# RENESAS TECHNICAL UPDATE

Product Category	MPU/MCU		Document No.	TN-RA*-A0146A/E	Rev.	1.00
Title	Note about the interruption during the transition to low power modes		Information Category	Technical Notification		
Applicable Product	RA4M1, RA4M2, RA4M3, RA4E1, RA4E2, RA4T1, RA4W1, RA4L1, RA6M1, RA6M2, RA6M3, RA6M4, RA6M5, RA6E1, RA6E2, RA6T1, RA6T2, RA6T3 Group		Lot No.	Reference Document	Refer table at the end of this document	
			All

1) Figure 10.1 of RA4M2, RA4M3, RA4E1, RA4E2, RA4T1, RA6M4, RA6M5, RA6E1, RA6E2, RA6T2, and RA6T3 groups

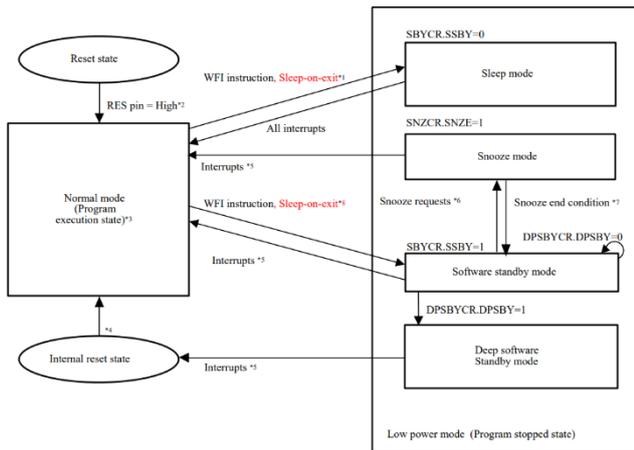
- Note 1. When an interrupt that acts as a trigger for cancel is received during a transition to the program-stopped state after the execution of a WFI instruction, the MCU executes interrupt exception handling instead of transitioning to low power mode.

- Note 1. When an interrupt that acts as a trigger for cancellation of the Sleep mode state is received during a transition to the Sleep mode state, the MCU does not transit to Sleep mode state but go back to Normal mode state.

- Note 5. See Table 10.3
- Note 6. See Table 10.7
- Note 7. See Table 10.9
- Note 8. When an interrupt that acts as a trigger for cancellation of the Sleep mode state is received during a transition to the Software Standby mode state, the MCU does not transit to Software Standby mode state but go back to Normal mode state.

2) Figure 11.1 of RA6M1, RA6M2, RA6M3, and RA6T1 groups

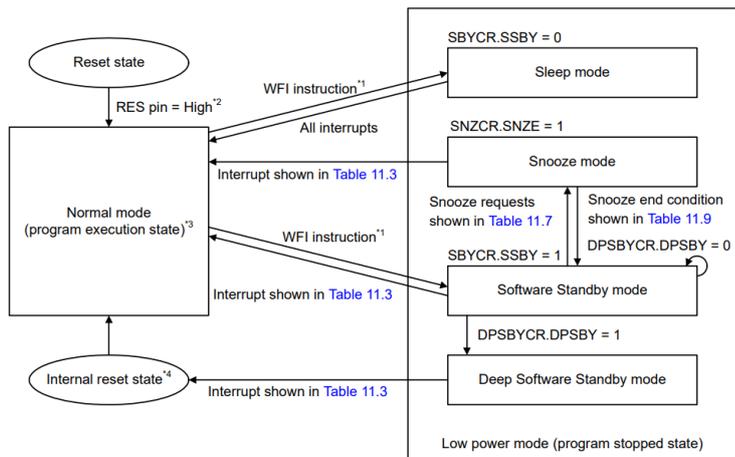
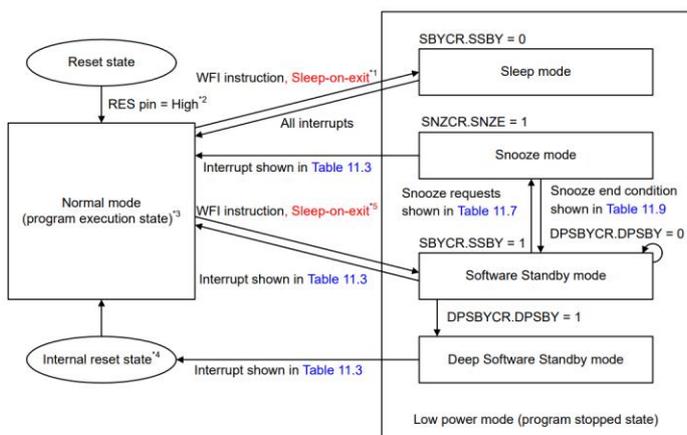
- Note 1. When an interrupt that acts as a trigger for cancel is received during a transition to the program-stopped state after the execution of a WFI instruction, the MCU executes interrupt exception handling instead of transitioning to low power mode.

- Note 1. When an interrupt that acts as a trigger for cancellation of the Sleep mode state is received during a transition to the Sleep mode state, the MCU does not transit to Sleep mode state but go back to Normal mode state.

- Note 5. When an interrupt that acts as a trigger for cancellation of the Sleep mode state is received during a transition to the Software Standby mode state, the MCU does not transit to Software Standby mode state but go back to Normal mode state.

3) Figure 10.1 of RA4M1group

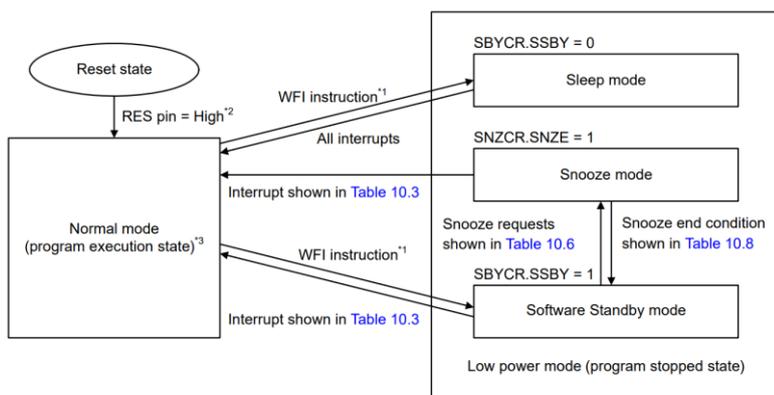
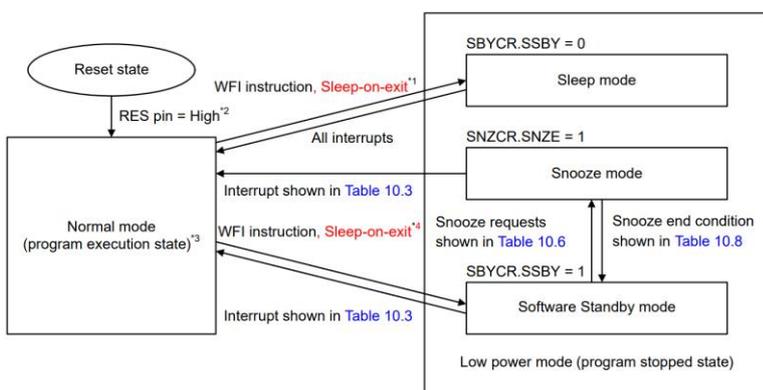
- Note 1. When an interrupt that acts as a trigger for cancel is received during a transition to the program stopped state after the execution of a WFI instruction, the MCU executes interrupt exception handling instead of a transition to low power mode.
- Note 2. The MOCO clock is the source of the operating clock following a transition from the reset state to Normal mode.
- Note 3. The transition to Normal mode is made from an interrupt in Sleep mode, Software Standby mode, or Snooze mode. The clock source is the same as before entering the low power mode.

- Note 1. When an interrupt that acts as a trigger for cancellation of the Sleep mode state is received during a transition to the Sleep mode state, the MCU does not transit to Sleep mode state but go back to Normal mode state.
- Note 2. The MOCO clock is the source of the operating clock following a transition from the reset state to Normal mode.
- Note 3. The transition to Normal mode is made from an interrupt in Sleep mode, Software Standby mode, or Snooze mode. The clock source is the same as before entering the low power mode.
- Note 4. When an interrupt that acts as a trigger for cancellation of the Sleep mode state is received during a transition to the Software Standby mode state, the MCU does not transit to Software Standby mode state but go back to Normal mode state.

4) Figure 11.1 of RA4W1 group

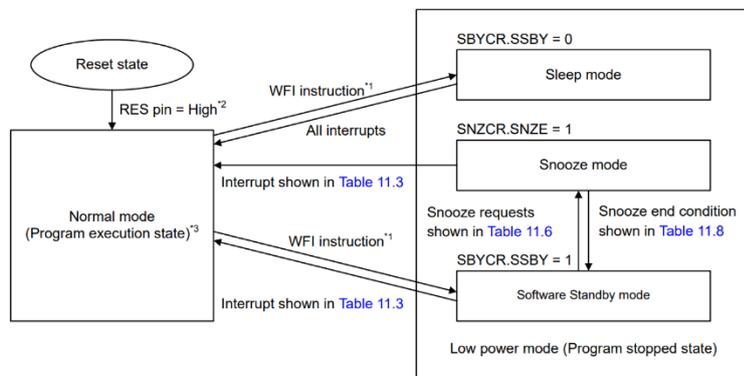
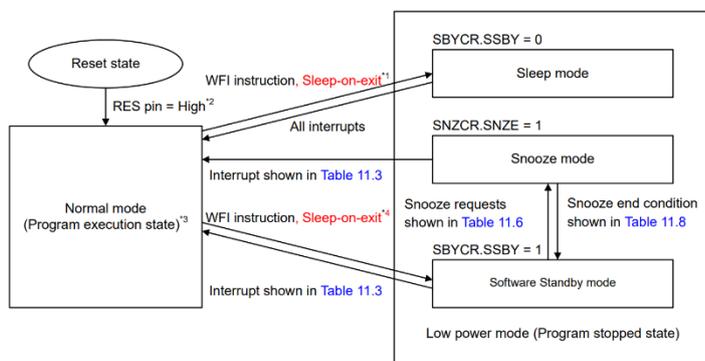
- Note 1. When an interrupt that acts as a trigger for cancel is received during a transition to the program stopped state after the execution of a WFI instruction, the MCU executes interrupt exception handling instead of a transition to low power mode.
- Note 2. The MOCO is the source of the operating clock following a transition from the reset state to Normal mode.
- Note 3. The transition to Normal mode is made from an interrupt in Sleep mode, Software Standby mode, or Snooze mode. The clock source is the same as before entering the low power mode.

- Note 1. When an interrupt that acts as a trigger for cancellation of the Sleep mode state is received during a transition to the Sleep mode state, the MCU does not transit to Sleep mode state but go back to Normal mode state.
- Note 2. The MOCO is the source of the operating clock following a transition from the reset state to Normal mode.
- Note 3. The transition to Normal mode is made from an interrupt in Sleep mode, Software Standby mode, or Snooze mode. The clock source is the same as before entering the low power mode.
- Note 4. When an interrupt that acts as a trigger for cancellation of the Sleep mode state is received during a transition to the Software Standby mode state, the MCU does not transit to Software Standby mode state but go back to Normal mode state.

5) Figure 10.1 of RA4L1 group

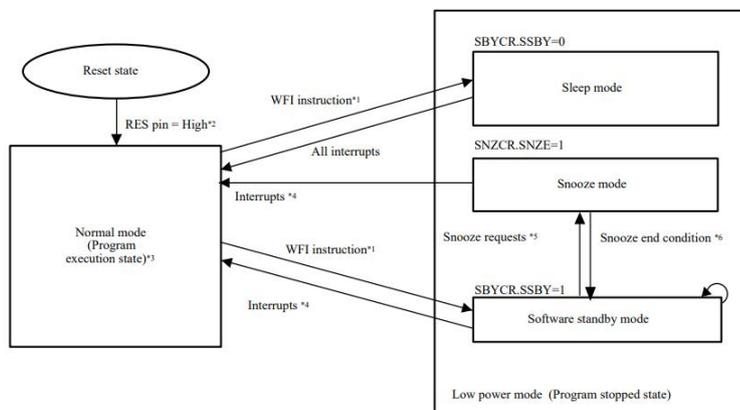
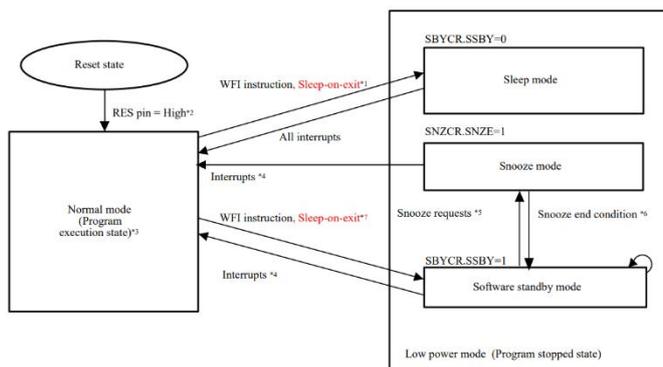
- Note 1. When an interrupt that acts as a trigger for cancel is received during a transition to the program-stopped state after the execution of a WFI instruction, the MCU executes interrupt exception handling instead of transitioning to low power mode.
- Note 2. The MOCO clock is the source of the operating clock following a transition from the reset state to Normal mode.
- Note 3. The transition to Normal mode is made because of an interrupt from Sleep mode, Snooze mode, or Software Standby mode. The clock source is the same as before entering the low power mode.
- Note 4. See Table 10.3.
- Note 5. See Table 10.8.
- Note 6. See Table 10.10.

- Note 1. When an interrupt that acts as a trigger for cancellation of the Sleep mode state is received during a transition to the Sleep mode state, the MCU does not transit to Sleep mode state but go back to Normal mode state.
- Note 2. The MOCO clock is the source of the operating clock following a transition from the reset state to Normal mode.
- Note 3. The transition to Normal mode is made because of an interrupt from Sleep mode, Snooze mode, or Software Standby mode. The clock source is the same as before entering the low power mode.
- Note 4. See Table 10.3.
- Note 5. See Table 10.8.
- Note 6. See Table 10.10.
- Note 7. When an interrupt that acts as a trigger for cancellation of the Sleep mode state is received during a transition to the Software Standby mode state, the MCU does not transit to Software Standby mode state but go back to Normal mode state.
